ALL DEVIATIONS FROM THE ORIGINAL DESIGN ARE SPECIFICALLY INDICATED WITH NOTES ON THIS RECORD DRAWING- Biohabitats, Inc.

DATE 04/14/11 SURVEYED BY JOB
SCALE 1"=100' DRAWN BY DWG. NO.
REVISIONS GREENBRIER-ASB-PROFILES-DESIGN ZONED

AS-BUILT SURVEY
GREENBRIER CREEK STREAM ENHANCEMENT
ALAMANCE AND CHATHAM COUNTIES
(ECOSYSTEM ENHANCEMENT PROGRAM)
SCO PROJECT #04-06210-02

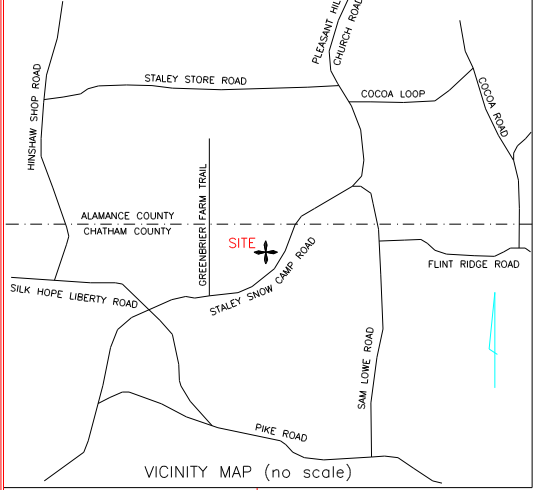
riffle invert changed from 568' to 567.5'

riffle invert changed from 567' to 567.5'

riffle invert changed from 564' to 564.5'

grading modified to avoid tree

invert of riffles raised 0.5 ft. during construction

approximately 30' of rock toe protection added during construction

riffle moved downstream 13' to 209+63 due to bedrock

rock step not installed as designed, natural bedrock is stabilizing already

riffle moved upstream 10' to 215+00 due to bedrock

grading modified to avoid trees

grading modified due to bedrock

riffle moved 17' upstream to 218+37 to avoid trees
